To: T10 Technical Committee  
From: Rob Elliott, HP (elliott@hp.com)  
Date: 6 November 2006  
Subject: 05-381r7 SAS-2 Multiplexing

Figure 8 — State machines for expander devices [\[updated to include logical phys\]](#)

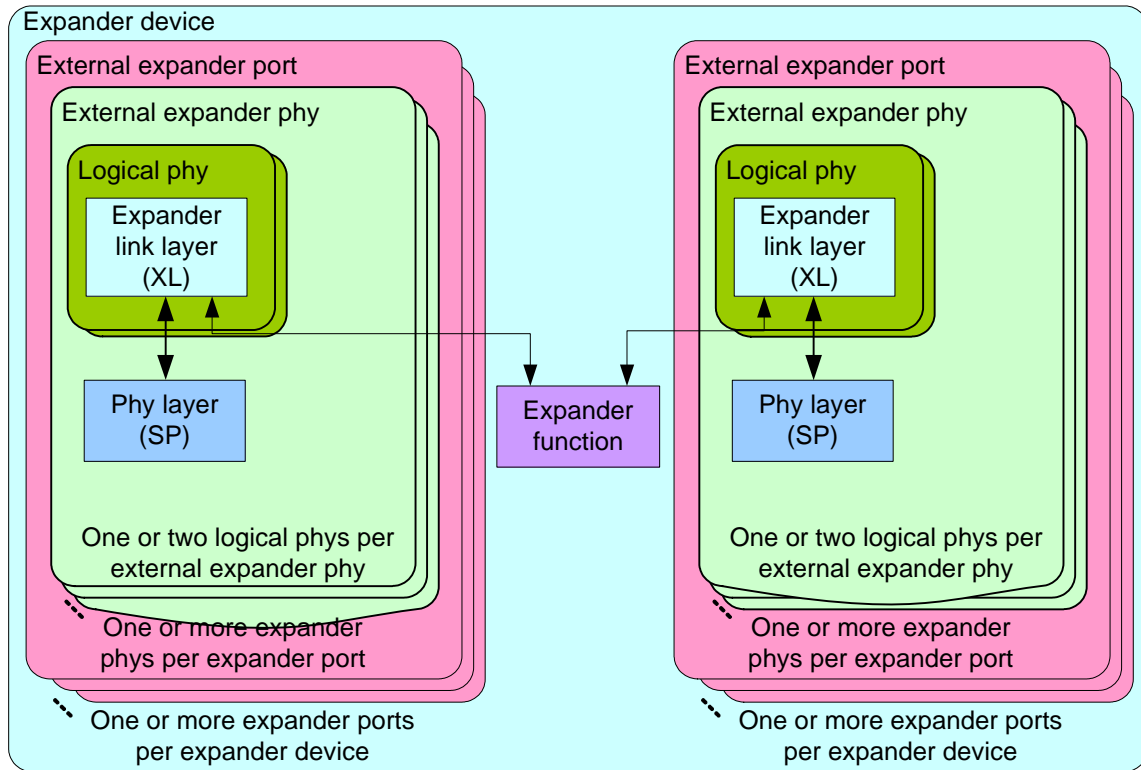
Editor's Note 2: Consider including SL\_IR in the previous figure alongside XL. It goes in the logical phy. It should probably be renamed SXL\_IR or L\_IR so the name doesn't imply it is only used by SAS phys.

Figure 11 — Receive data path in a SAS phy [\[updated\]](#)

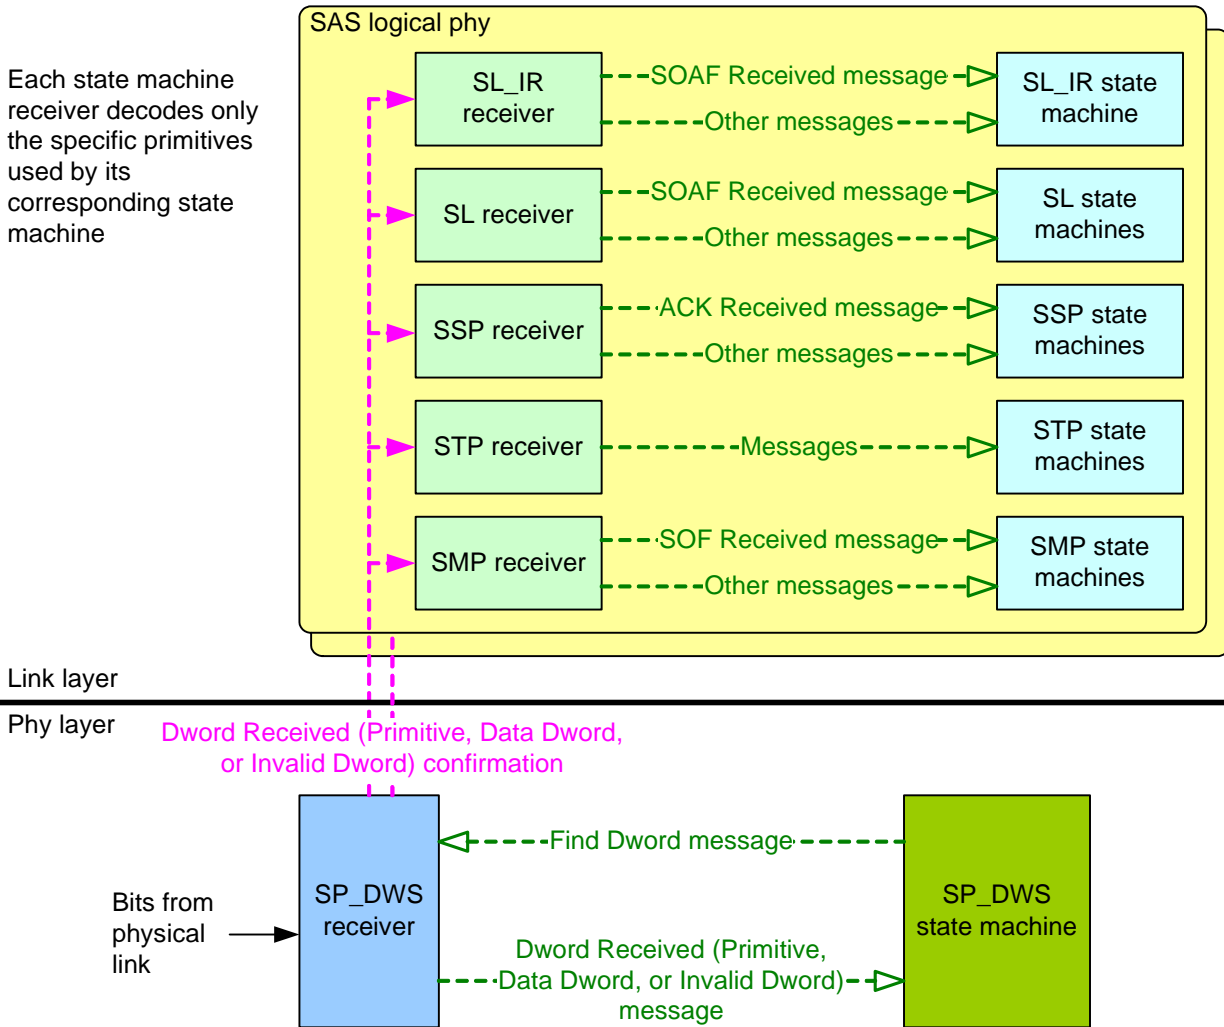
If multiplexing is enabled (see table 14 in x.y), the SP\_DWS receiver uses incoming MUX primitives to determine the logical link numbers and route the dwords to the appropriate link layer receivers.

Figure 17 — SP\_DWS (phy layer dword synchronization) state machine [updated]

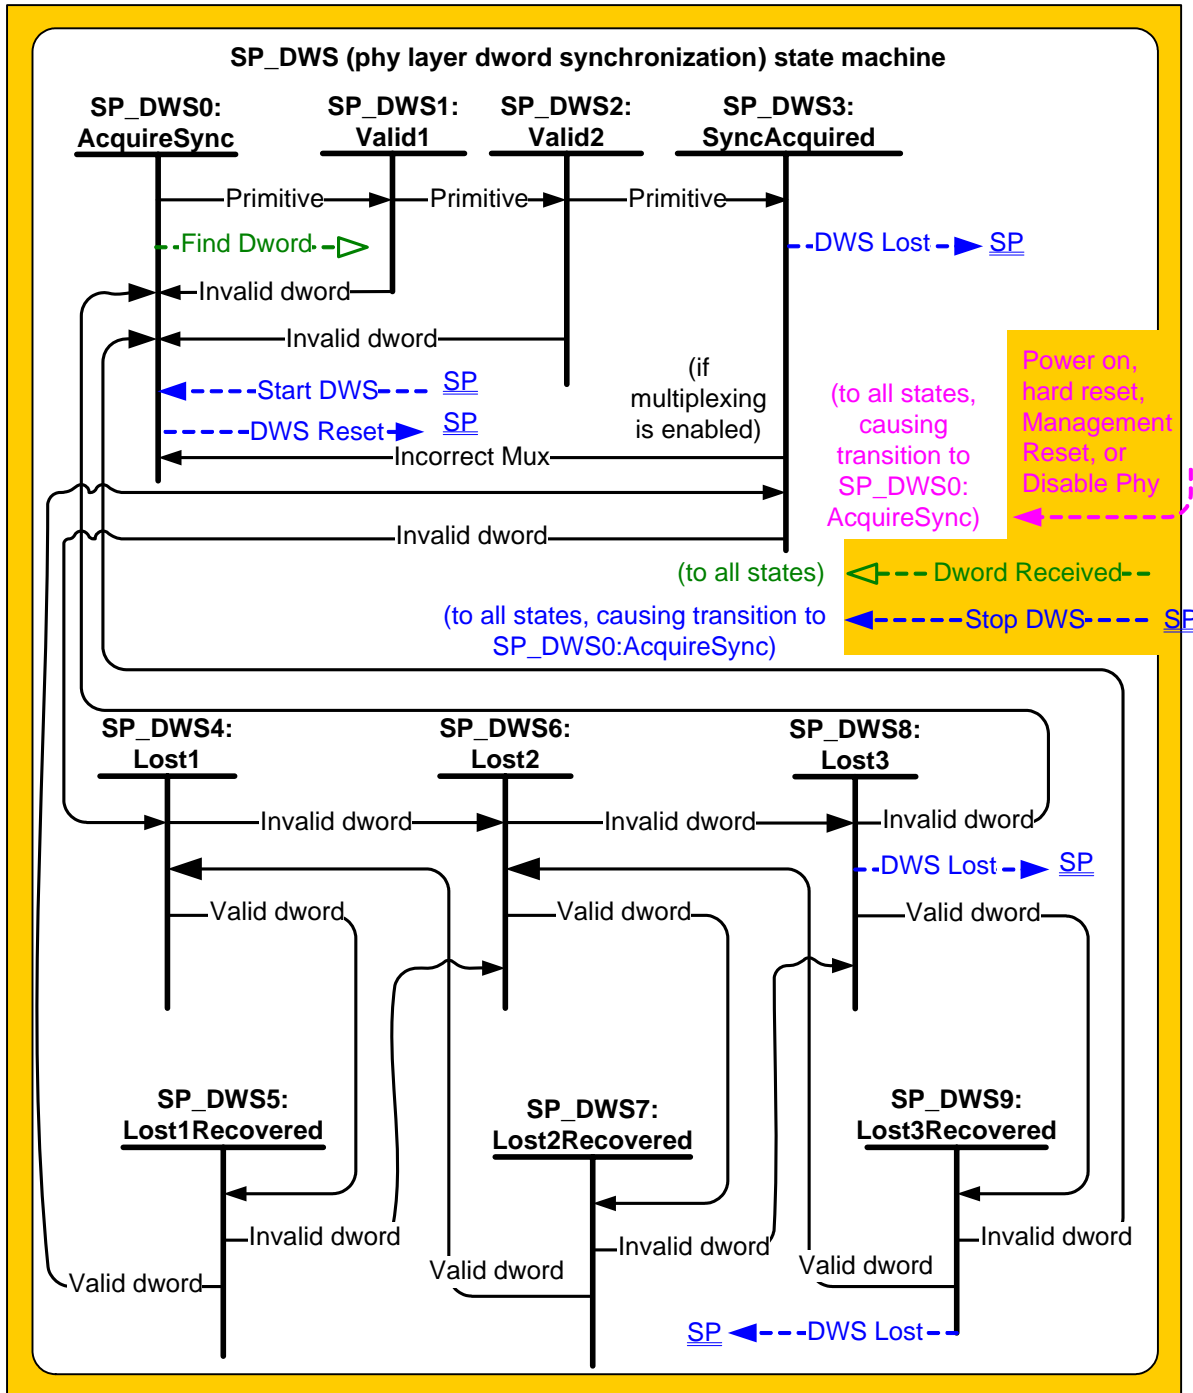
*Add MUX transmission to the SP state machine and make SP\_DWS cognizant of multiplexing. If multiplexing is enabled, the phy must give up immediately upon losing dword synchronization and not try to reacquire it, since it won't know which logical links are which.*

**Figure 23** — No multiplexing

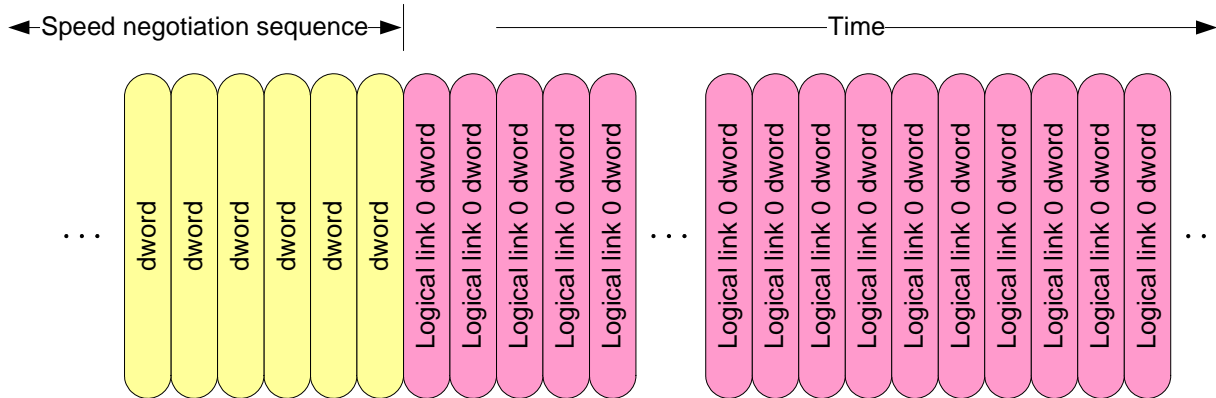
The phy shall align its incoming dword streams based on the first MUX it receives. The phy shall process MUX primitives in logic running off the received clock without using an elasticity buffer, because they are not accompanied by additional deletable primitives (e.g., ALIGNs and/or NOTIFYs).

Figure 25 shows no multiplexing (i.e., multiplexing into one logical link).

**Figure 24 — Multiplexing**

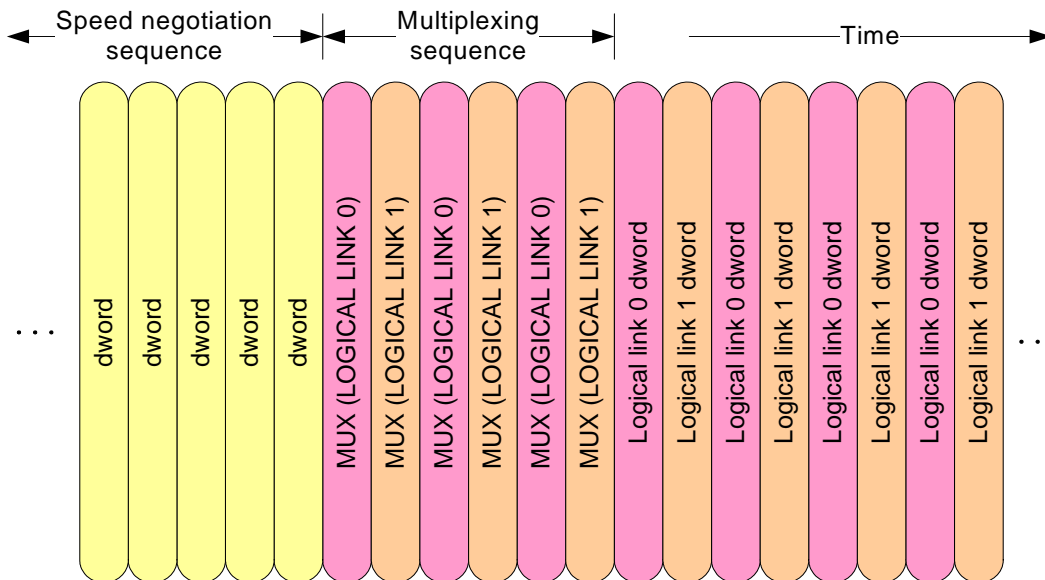
Figure 25 shows multiplexing into two logical links.

After the multiplexing sequence completes, each logical phy shall honor the deletable primitive insertion requirements for clock skew management defined in 7.3. The logical phys shall ignore MUX primitives.

**Figure 25 — Identification sequence**

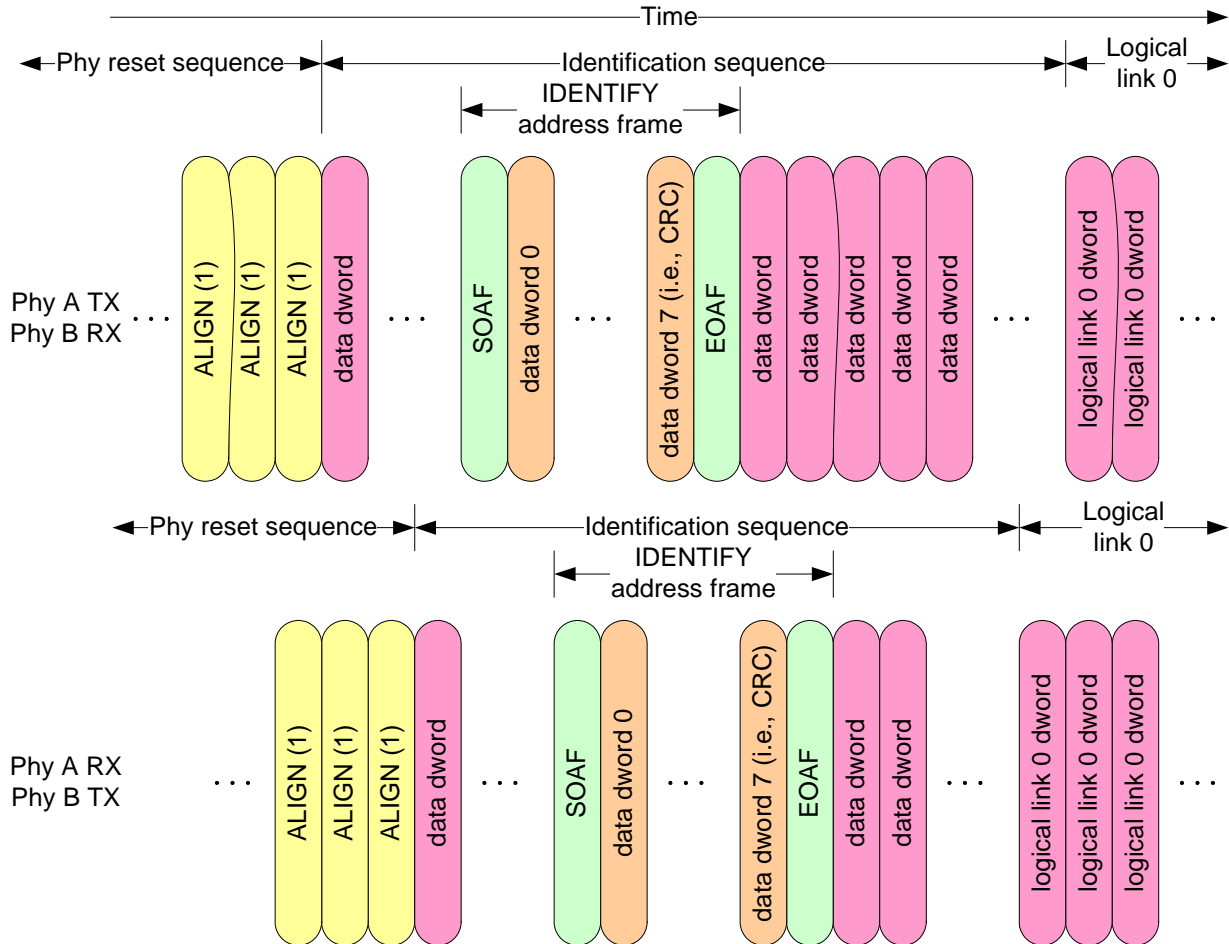
If multiplexing is enabled (see table 14 in x.y), the identification sequence and hard reset sequence begin with a multiplexing sequence (see 7.xx).

Figure 25 shows two phys with multiplexing disabled performing the identification sequence.

Figure 27 — Rate matching example [changed]

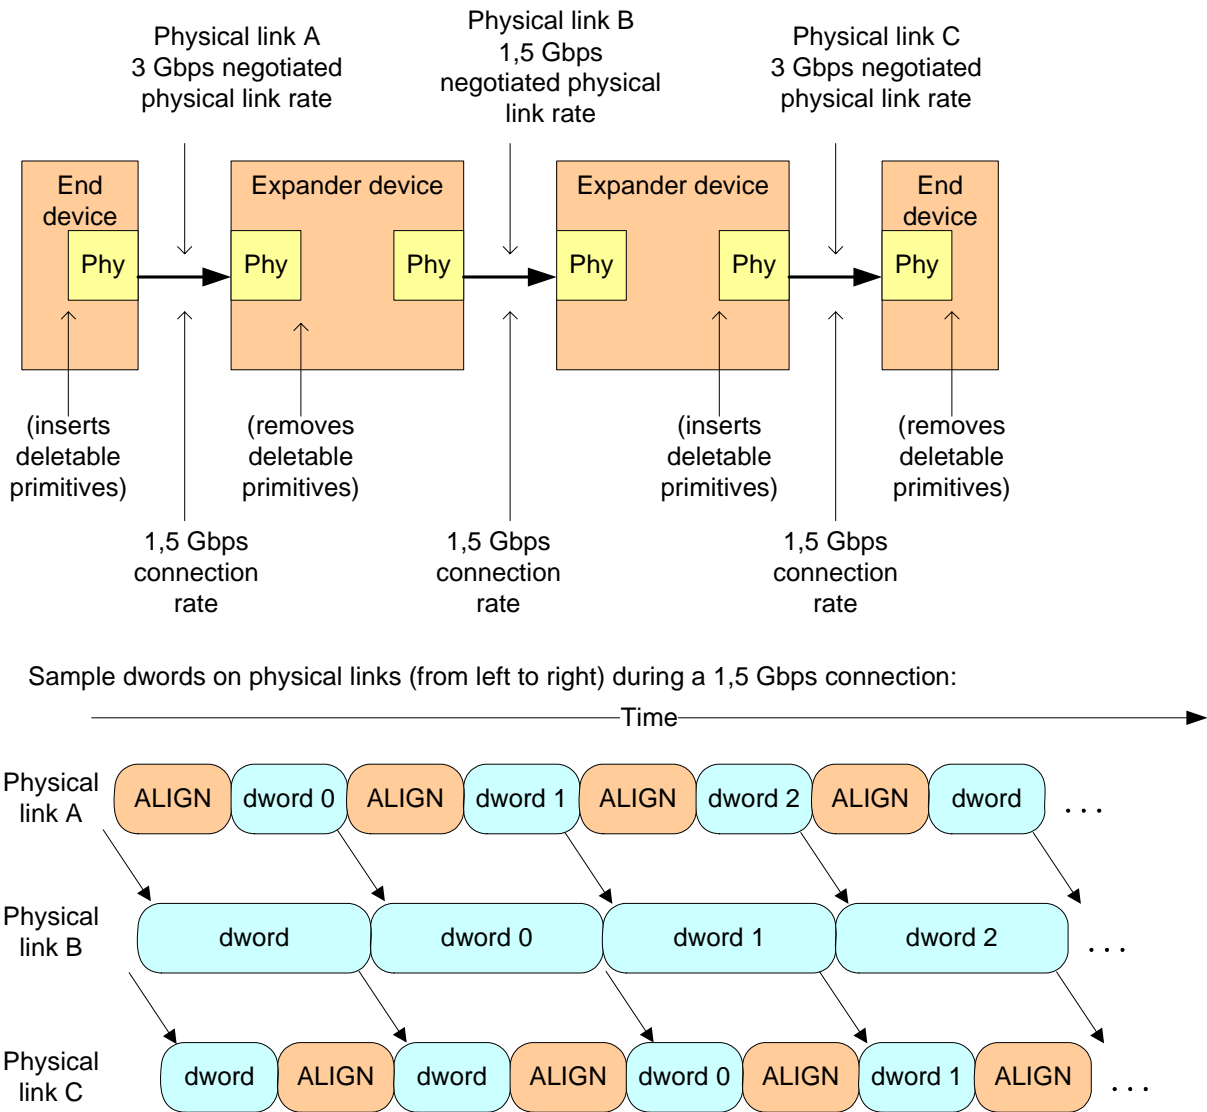
~~ALIGNs and NOTIFYs~~Deletable primitives inserted for rate matching are in addition to ~~ALIGNs and NOTIFYs~~deletable primitives inserted for clock skew management (see 7.3) and STP initiator phy throttling (see 7.17.2). See Annex H for a summary of their combined requirements.
